MEMORANDUM

SUBJECT: 30 and 40 Newport Parkway

The Division of Transportation Planning and Division of Traffic Engineering reviewed the site plan and traffic impact study submitted by Dresdner Robin and Enovate, respectively.

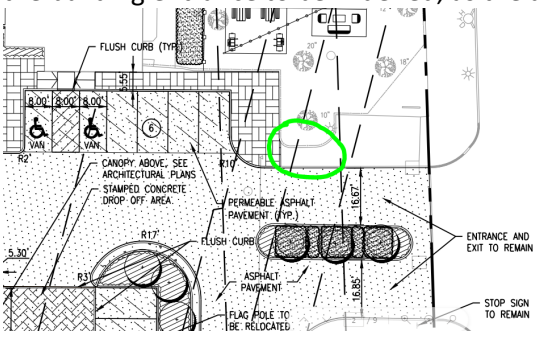
(a) The proposed reconfiguration of the surface parking lot provides an opportunity to improve the pedestrian crossing of the driveway to conform to Jersey City standard design for driveways. Please redesign such that the sidewalk is continued at-grade across the driveway. The existing ADA ramps can then be removed.

(b) The Divisions would prefer that the driveway be narrowed to reduce the width of the conflict zone between the driveway and sidewalk. This would also enable the path from the sidewalk leading to the building entrance to be widened, as the adjacent property's fence causes a pinch point.

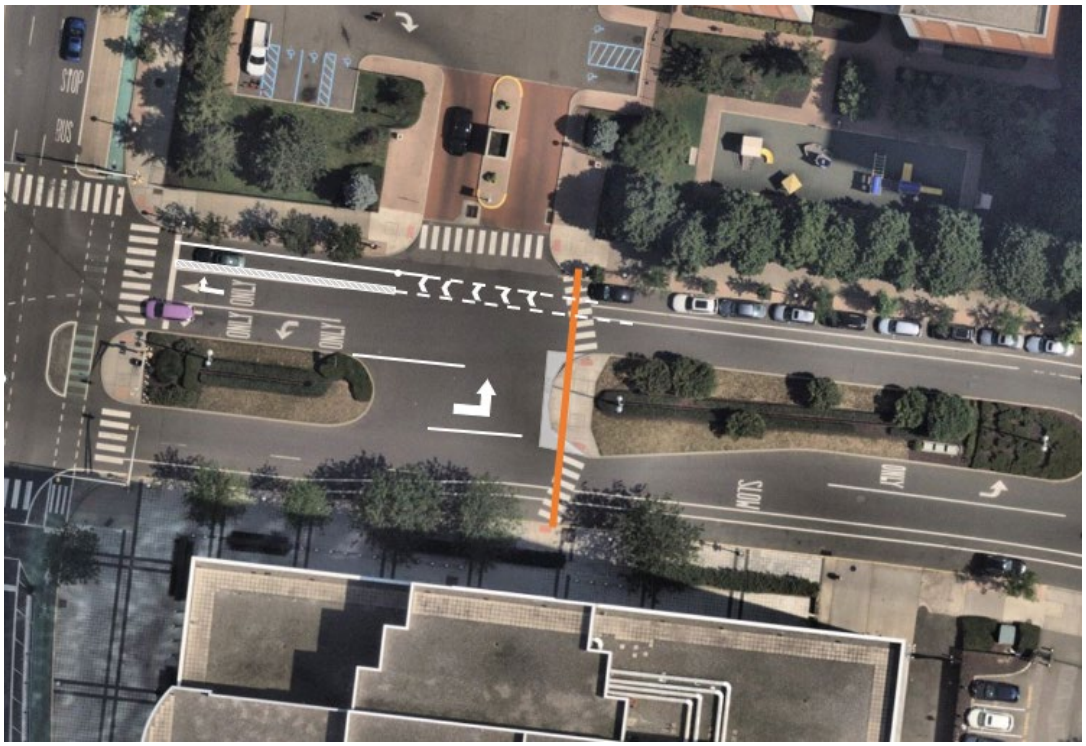
(c) The Divisions recommend minor changes to Newport Parkway in front of the site to improve safety, especially for vehicles making a left turn into the driveway. The Divisions recommend an eastbound left turn queue lane in the area between the existing medians, with delineators along the northern edge line to deter left turns out of the driveway.

(d) To improve the existing pedestrian crossing and deter u-turns at the eastern median, the Divisions request that the median be squared off and that the pedestrian crosswalk striping be straightened.

(e) To provide a continuous and safer bike route across the site, the Divisions request that the applicant extend the existing bike lane to the intersection of Washington Boulevard. The right-turn only lane would be replaced by a bike lane with a 3' wide buffer. Please include 1 or 2 flexible delineator posts where the bike lane widens at a width suitable to allow cyclists through, but narrow enough to deter vehicles from entering the bike lane.

Below is a rough sketch of proposed changes to the street described in these comments. Please coordinate final striping plans with the Divisions of Transportation Planning and Traffic Engineering prior to installation.
